Revised East Leppington (Liverpool Part) Precinct Plan on Exhibition

Thank you for your letter dated 30 July 2013, requesting Transport for NSW (TfNSW) provide comment on the revised draft East Leppington (Liverpool Part) Precinct Plan.

Figure 1 Proposed Bus Stop Locations

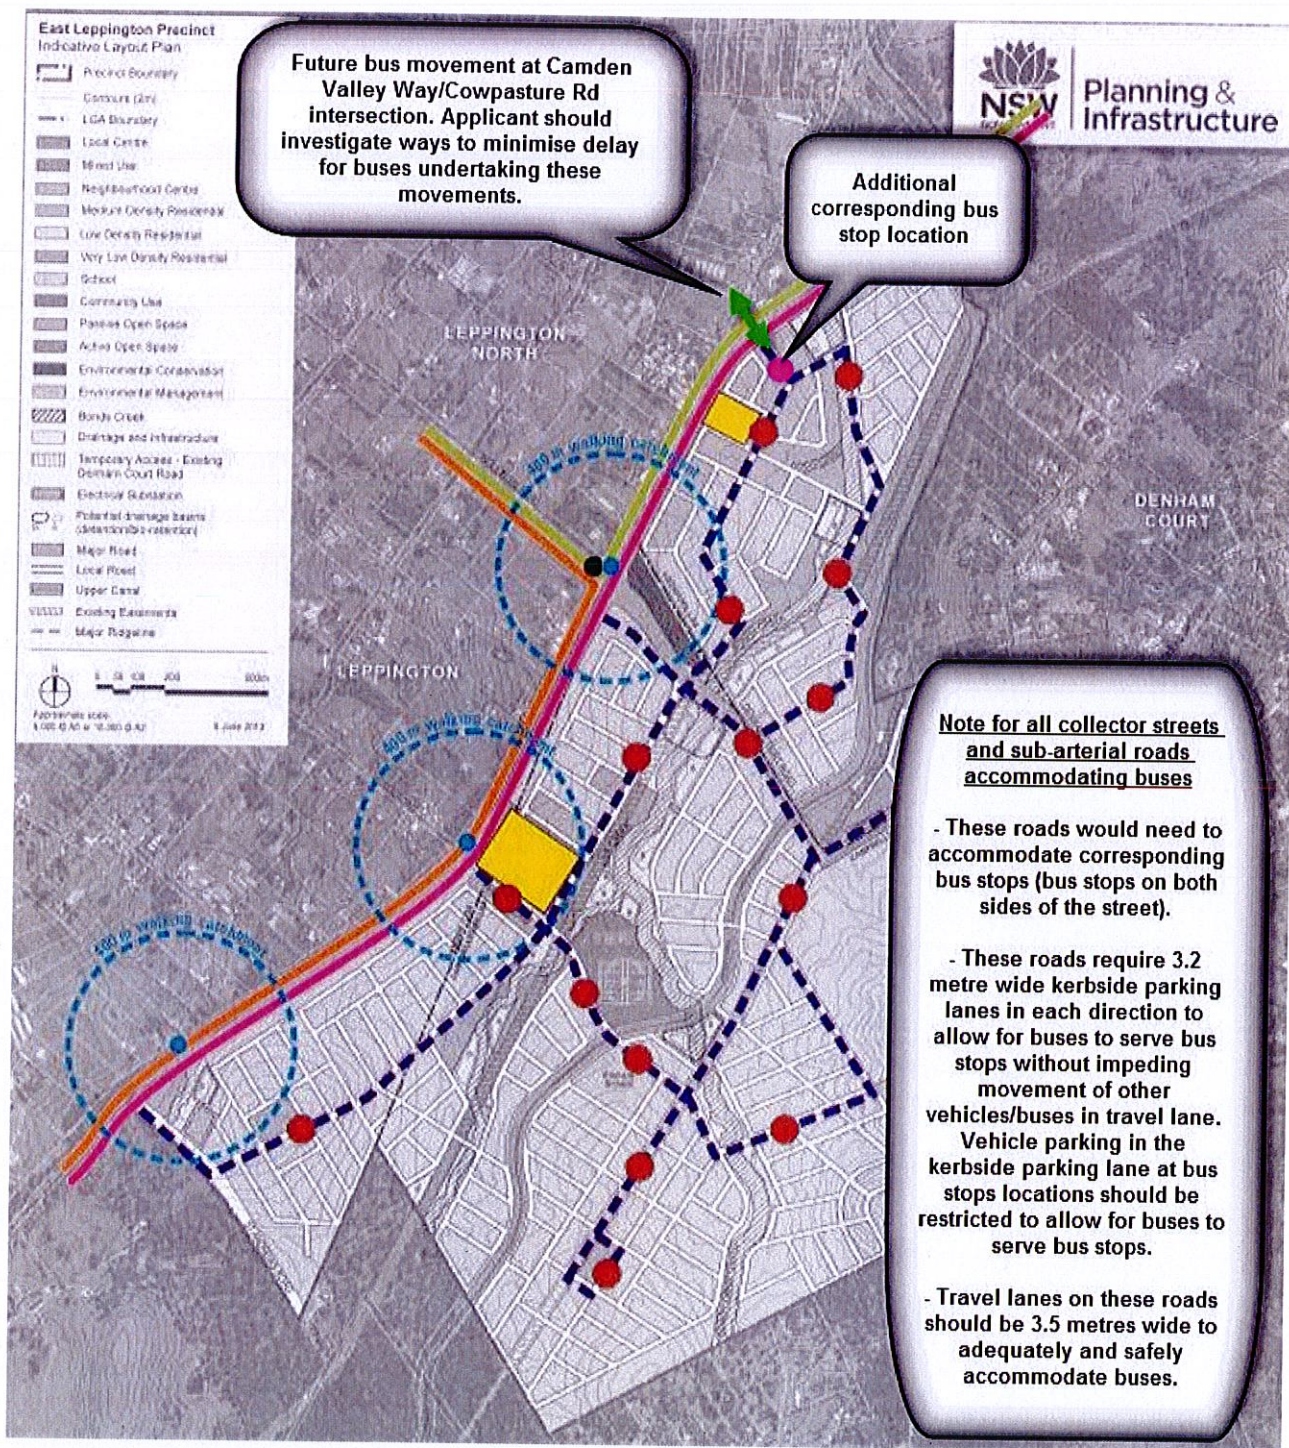
- TfNSW supports the proposed internal bus route roads and recommends a 3.2 metre wide kerbside parking lane in each direction to allow for buses to serve bus stops without impeding movement of other vehicles/buses in the travel lane. Vehicle parking in the kerbside parking lane at bus stop locations should be restricted to allow for buses to serve bus stops. Travel lanes on these roads should be at least 3.5 metres wide to adequately and safely accommodate buses.
- TfNSW supports proposed indicative bus stop locations however recommends the inclusion of an additional bus stop location, indicated in pink in Figure 1. Note that all bus stop locations require corresponding bus stops (i.e. located opposite each other on both sides of the street).
